**PLPSP20220079 – ARCO Preliminary Site Plan & SEPA Checklist
Preliminary SEPA Mitigated Determination of Non-Significance (MDNS)
Public Comment Period**

Please see the following documents for the SEPA Preliminary Mitigated Determination of Non-Significance (MDNS) for project number PLPSP20220079 for the development of tax parcels 7730000281 and 7730000031 for an ARCO gas station, car wash, and AMPM convenience store.

MITIGATED DETERMINATION OF NON-SIGNIFICANCE (MDNS)

Project # PLPSP20220079

Existing access off of
S Meridian

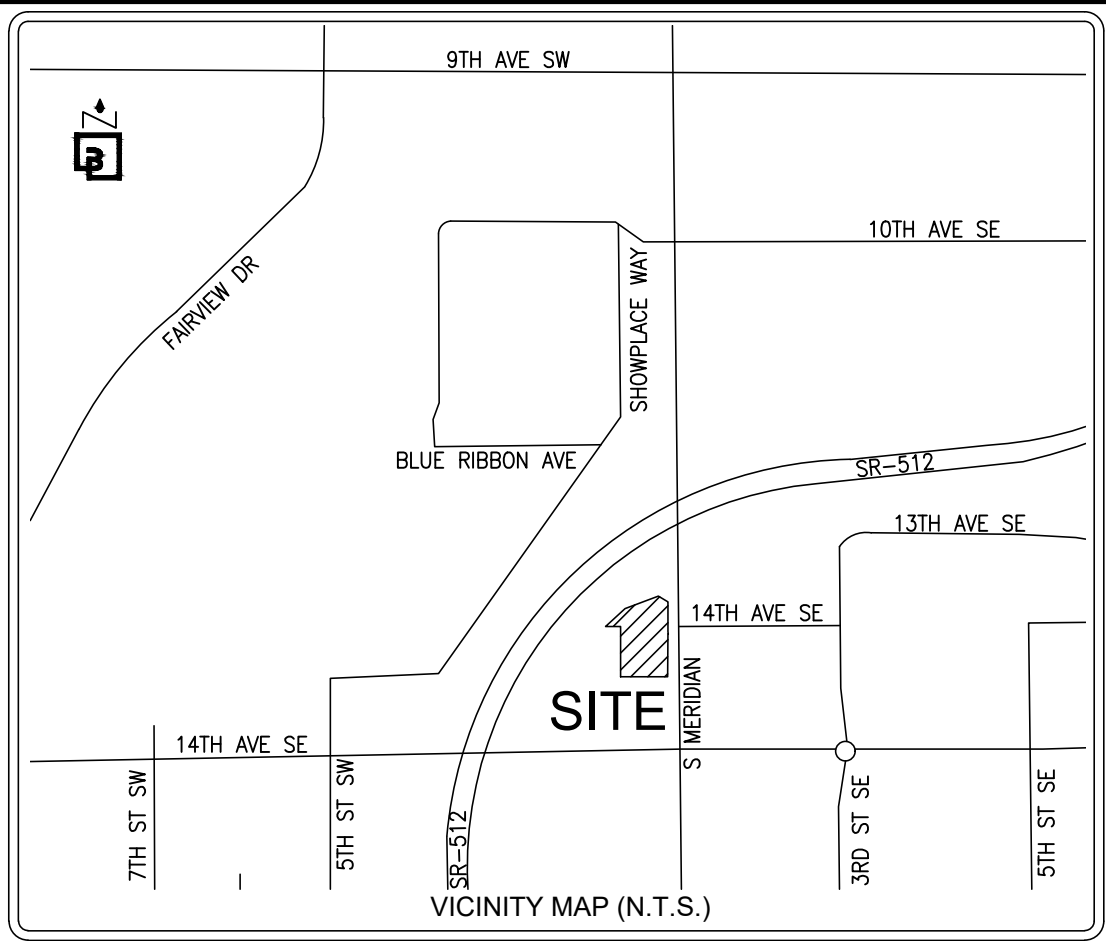
The original notice of application for this project was sent to you on May 24, 2022. Since then, the access requirement for this project has changed. In order to meet City of Puyallup requirements and to protect public safety, the access along S Meridian is required to become a right-in/right-out ingress/egress. We understand that this change to the shared easement may affect your property. If you have questions about this issue, please contact Ken Cook, Engineering Services Manager at: KCook@PuyallupWA.gov or (253) 864-4177

15 Ave SW driveway
approach to be
improved

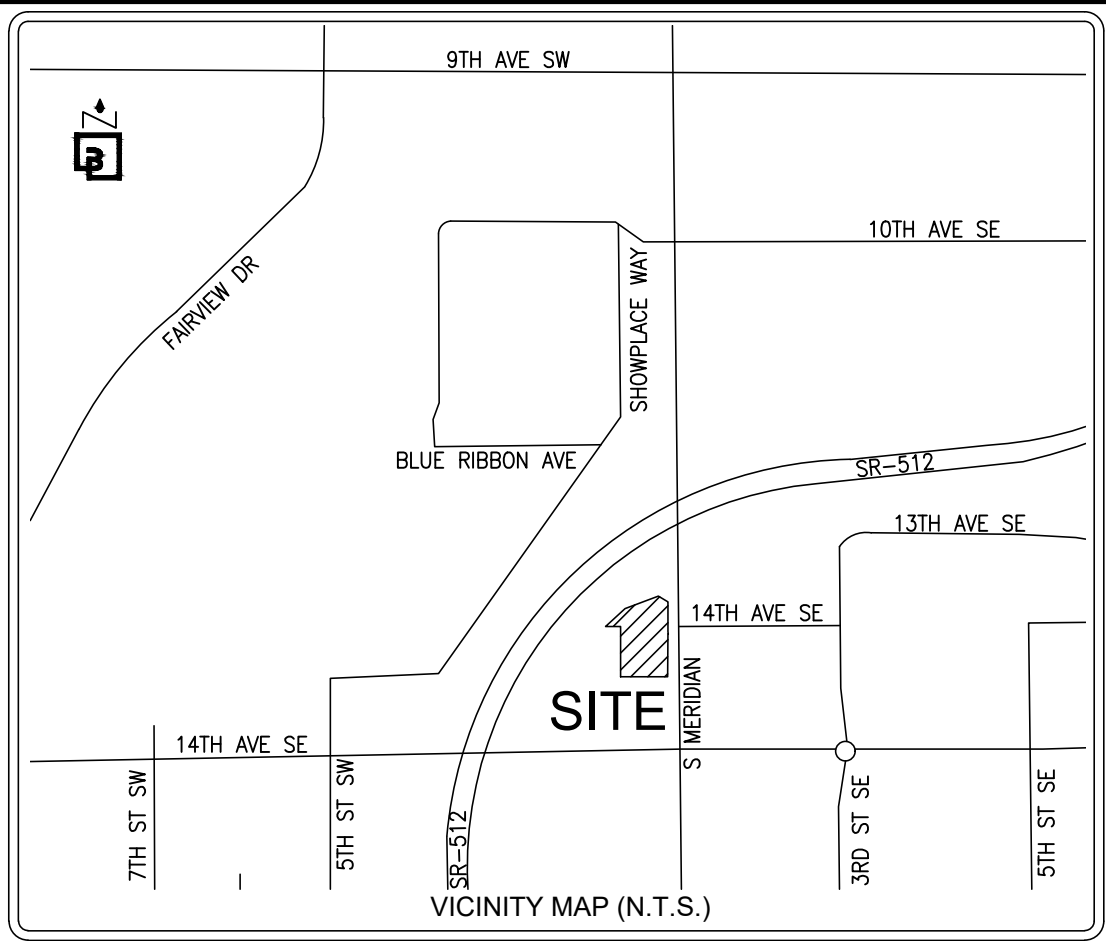
- d. The driveway approach along 15th Ave SE is substandard. Due to the influx in traffic per the proposed development, this driveway approach will need to be repaired to meet current city standards and ADA accessibility. The project will be required to upgrade the approach within the existing (east-west) footprint and revise the current angle of inclination (north-south) to ensure vehicles entering/leaving the site will not "bottom out" causing continuous damage to this approach.

- e. Access revision at Meridian creates limitations of fire apparatus access to the site per IFC 503.1.2 secondary access is required from 15th Ave SW. Fire Apparatus Access on 15th Ave SW - entrance needs to be improved per City engineering standards; addressing angle of inclination requirements, potholes and deterioration of the pavement for all weather driving surface per IFC 503.2.3.
